Second Revision No. 8623-NFPA 70-2021 [Detail]

Committee: NEC-P07

Figure 552.44(C)(1) Attachment Cap and Receptacle Configurations.

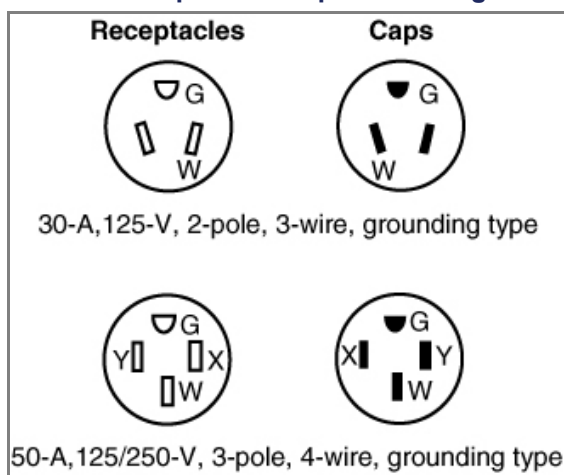
**Second Revision No. 8676-NFPA 70-2021 [Section No. 552.44(C)(2)]****(2) Units with 50-Ampere Power-Supply Feeder Assembly.**

Park trailers having a power-supply feeder assembly rated 50 amperes as permitted by 552.43(B) shall have a 3-pole, 4-wire grounding-type attachment plug rated 50 amperes, 125/250 volts, conforming to the configuration shown in Figure 552.44(C)(1).

Committee Statement: The definition for Feeder Assembly was revised and moved to Article 100, this SR changes the term “power supply assembly” to the defined term “feeder assembly” to correlate with this global change.
